ADDENDUM #1

ALTERATION & RENOVATION - NEW
HANOVER PUBLIC SCHOOL
New Hanover Township BOE
RYEB Project #5260Ca/Cb AS

WSK 1.0

AMENDED DOOR/FRAME TYPES

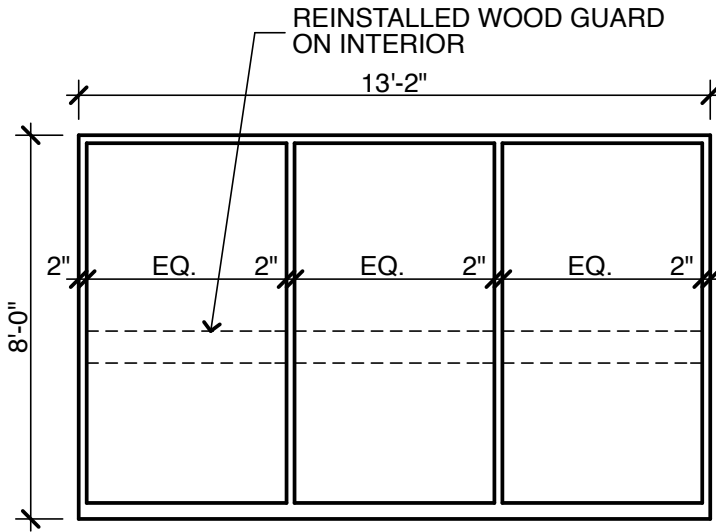
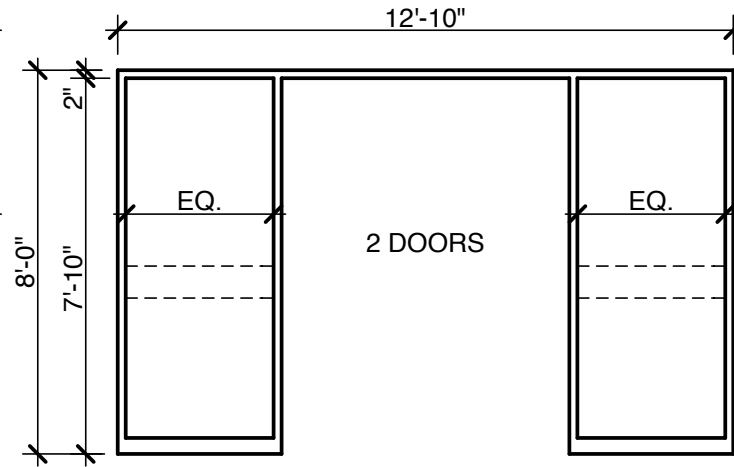
- 1.01 AMENDMENT: (Reference to attached WSK 1.0 and WSK 2.0 sketches): Amend the following:
- A. Amend the doorframes as indicated in WSK 1.0; titled as "Amended Door/Frame Types". All other door/frame types on the contract documents remain unchanged.
